WOLF CREEK

Subject: Docket No. 50-482: Request for Relief From ASME
Section XI Hydrostatic Testing of Class 1 and Class 2
Pressure Boundaries

INSERVICE INSPECTION RELIEF REQUEST

FIGURE 1
General RCS Pressure Isolation
Valve Pressure Boundary
Representation
(Bold lines represent boundary
subject to relief)

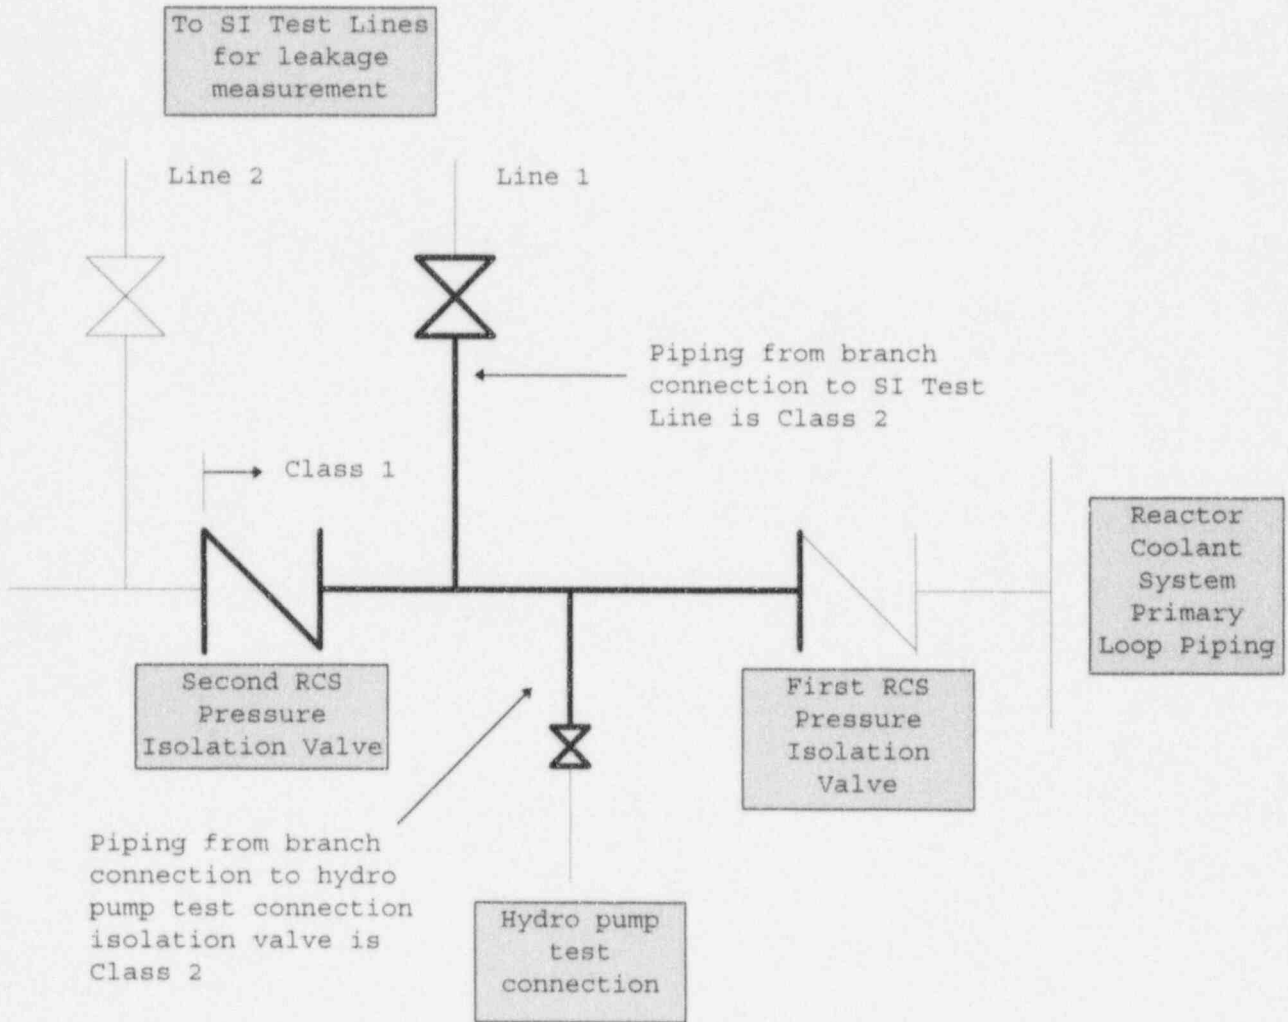
Hydrostatic testing of ASME Class 1 and Class 2 pressure boundaries between RCS Pressure Isolation Valves (subject boundaries utilize check valves). These pressure boundaries include a Class 2 piping connection from the Class 1 portion of piping to the associated Safety Injection System Test Line Isolation Valve (Reference Figure 1).

Code testing requirements for the subject boundaries include testing at 1.02 times operating pressures for the Class 1 portions and 1.25 for the Class 2 portions with a 4 hour hold time for insulated portions of systems which includes the subject pressure boundaries of this request for relief. Waiting for the required hold time with subsequent visual examination can substantially extend outage time (e.g., testing of the subject branch connections with the 4 hour hold time can result in an additional 36 hours of critical path time). Personnel exposure is also greatly affected because the subject pressure boundaries are located within the primary personnel protection wall, typically referred to as the "bioshield." Insulation removal to reduce the ASME Code required hold time to ten minutes is not a viable option since this would require a substantial increase in the number of man-hours spent within the bioshield which is typically a high radiation dose area. This also creates a personnel hazard associated with reinstallation of the insulation on the greater than 500°F piping surface. In addition, testing at the elevated hydrostatic testing pressures causes considerable hardship. To minimize schedule impact, this testing would be performed in conjunction with other plant startup activities such as RCS Pressure Isolation Valve testing. To attain the required conditions for the other testing, it would require an additional cycle of RCS pressurization as discussed below.

Recognizing that hydrostatic tests result in hardship and/or unusual difficulty without a compensating increase in the level of quality and safety, Wolf Creek Nuclear Operating Corporation proposes two alternatives to confirm that no boundary leakage is present at the subject locations. The description and technical basis of these alternatives are discussed as follows:

For the subject pressure boundaries verified as maintaining a pressure of at least 2000 psig (which is approximately 90% of RCS operating pressure) for the Code required hold time of 4 hours during the current fuel cycle (cycle 8), WCNOC requests relief from the First 10-Year Inservice Inspection Interval Section XI requirements for performing the 10-year system hydrostatic testing of the Class 1 and Class 2 pressure boundaries located between the RCS Pressure Isolation Valves. Relief is requested on the basis that the verification of pressure greater than 2000 psig for a minimum of four hours in combination with the inspections implemented as a result of Generic Letter 88-05 provide an alternative which provides an acceptable level of quality and safety. The implementation of a separate test to apply ASME Section XI 10-year system hydrostatic test pressure and hold time requirements to these pressure boundary locations would result in a hardship to WCNOC in the form of additional testing, financial burden and additional dose to personnel without a compensating increase in quality and safety.

For the subject pressure boundaries verified as not maintaining a pressure of at least 2000 psig for the Code required hold time of 4 hours during the current fuel cycle (cycle 8), WCNOG requests relief from the First 10-Year Inservice Inspection Interval Section XI requirements for performing the 10-year system hydrostatic testing of the Class 1 and Class 2 pressure boundaries located between the RCS Pressure Isolation Valves. Relief is requested on the basis that the combined boric acid monitoring program inspections implemented as a result of Generic Letter 88-05 and the comparison of the pressure source and leakage measurements, provide an alternative which provides an acceptable level of quality and safety. The implementation of a separate test to apply ASME Section XI 10-year system hydrostatic test pressure and hold time requirements to these pressure boundary locations would result in a hardship to WCNOG in the form of additional testing, financial burden and additional dose to personnel without a compensating increase in quality and safety.
